Seattle
Design
Commission

APPROVED
MINUTES OF THE MEETING
1 April 2004

1 April 2004 Project: **Joint Training Facility** (Olson Pl SW & Myers Way S)
Phase: Design Development
Previous Reviews: 15 May 2003 (Schematic Design); 16 January 2003 (Pre-Design)
Presenters: Dove Alberg, FFD
Martha Turnbull, FFD
Joe Chauncey, Boxwood
Darrell Turner, Boxwood
Melanie Mills, SvR Design
Attendees: Jeff Phillips, Boxwood
Sue Partridge, FFD
Brian Harris, TCA
Brian Mills, SFD
George Drayseth, SDOT

Perspective Drawing, Joint Training Facility

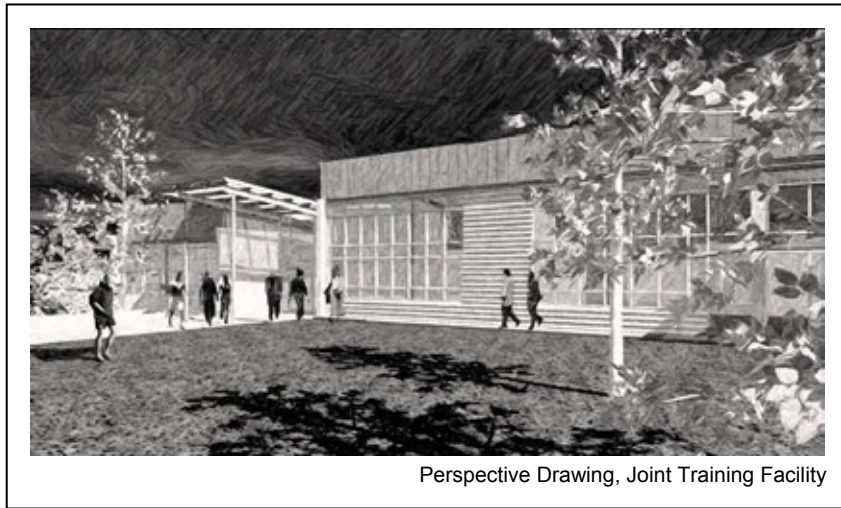
- Classroom building redesign is being handled well and the reduction has been positive with good design decisions along the way, such as the concealment of the mechanical penthouse.

- The choice of asphalt vs. concrete for paving on site to save money is a bit of a concern.
- Project is commendable on many fronts. Redesign of the classroom building to match the design of other buildings is critical to creating a campus feel.
